ATTACHMENT 2 TO AEP:NRC:0856 0

PROPOSED CHANGES TO THE
DONALD C. COOK NUCLEAR PLANT
UNIT NOS. 1 AND 2
TECHNICAL SPECIFICATIONS

AMERICAN ELECTRIC POWER SERVICE CORPORATION
D. C. COOK UNITS 1 AND 2
CONTROL ROOM DOSE EVALUATION

FIGURE 1: CONTROL ROOM VENTILATION SYSTEM

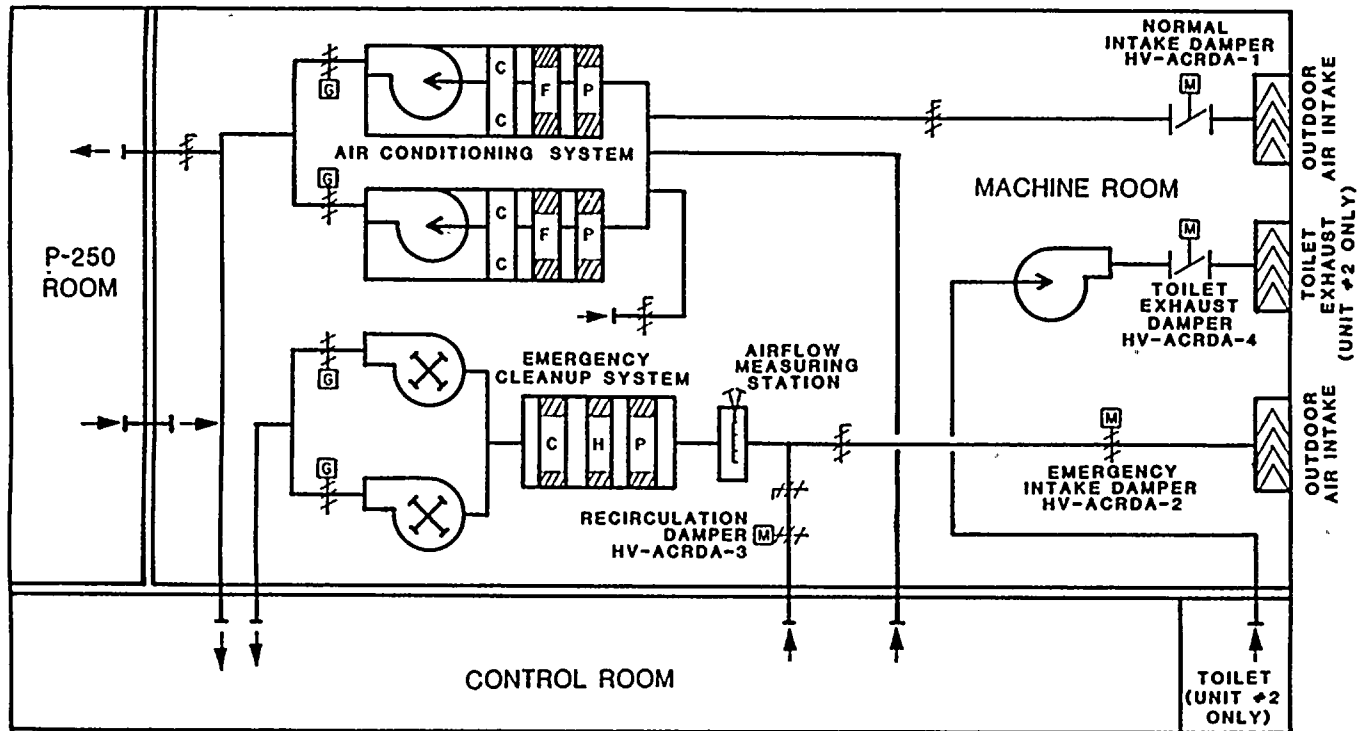
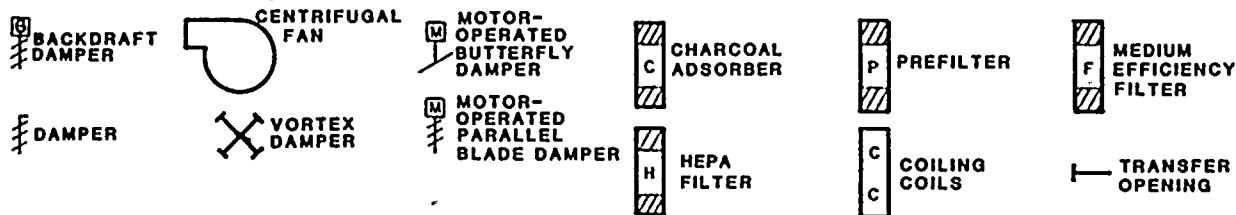
Figure 1, and its accompanying Table 1, provide a graphic representation of the control room ventilation system under normal, radiological, and toxic gas conditions.

<u>Equipment</u>	<u>Condition</u>
Damper ACRDA-1	Open
Damper ACRDA-2	Open to recirculation/cleanup setting
Damper ACRDA-3	Closed
Damper ACRDA-4	Closed or open
Pressurization Fans	Not running

<u>Equipment</u>	<u>Condition</u>
Damper ACRDA-1	Closed
Damper ACRDA-2	Open to recirculation/cleanup setting
Damper ACRDA-3	Closed
Damper ACRDA-4	Closed
Pressurization Fans	Not running

<u>Equipment</u>	<u>Condition</u>
Damper ACRDA-1	Closed
Damper ACRDA-2	Open to recirculation/cleanup setting
Damper ACRDA-3	Open
Damper ACRDA-4	Closed
Recirculation Fans	1 running

FIGURE 2: CONTROL ROOM BETA SKIN AND GAMMA BODY DOSE

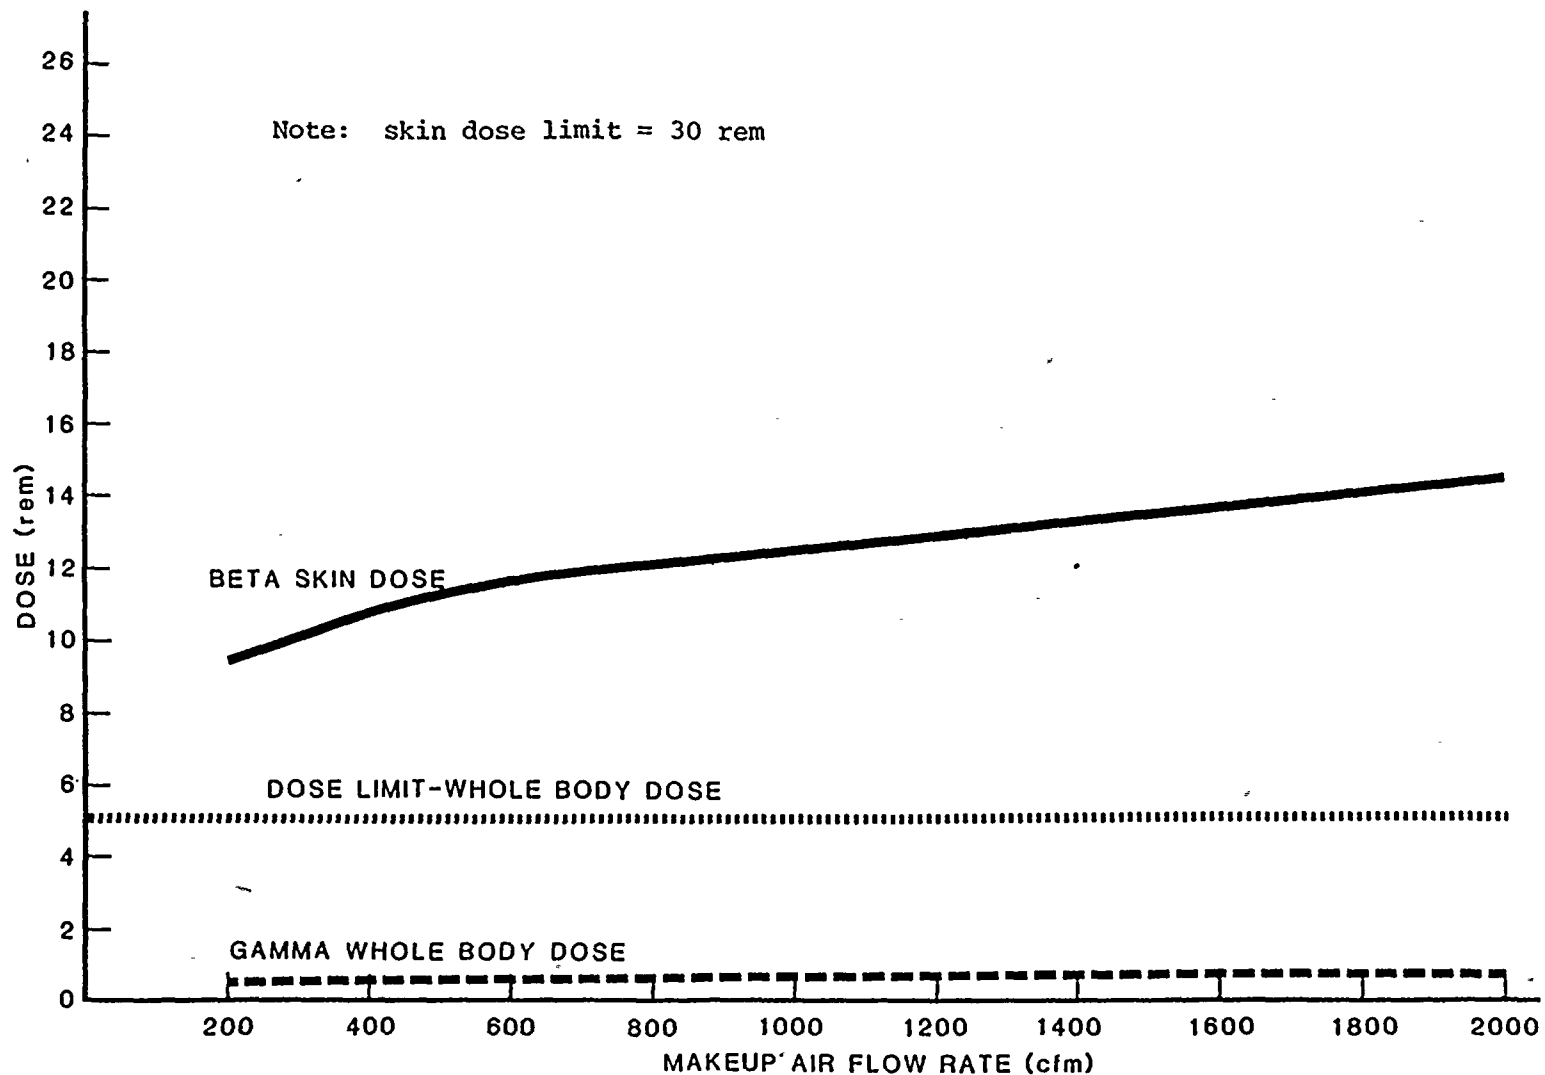
To use the whole body and skin dose curves, the total makeup air flow rate is obtained by summing the filtered and unfiltered values obtained as described above, and verifying that the 30-day dose resulting from this total is below the limits shown. For the thyroid dose, a point on Figure 3 is found which corresponds to the appropriate filtered and unfiltered leakage combination. The 30-day dose associated with this point must be below the 30 rem thyroid dose limit.
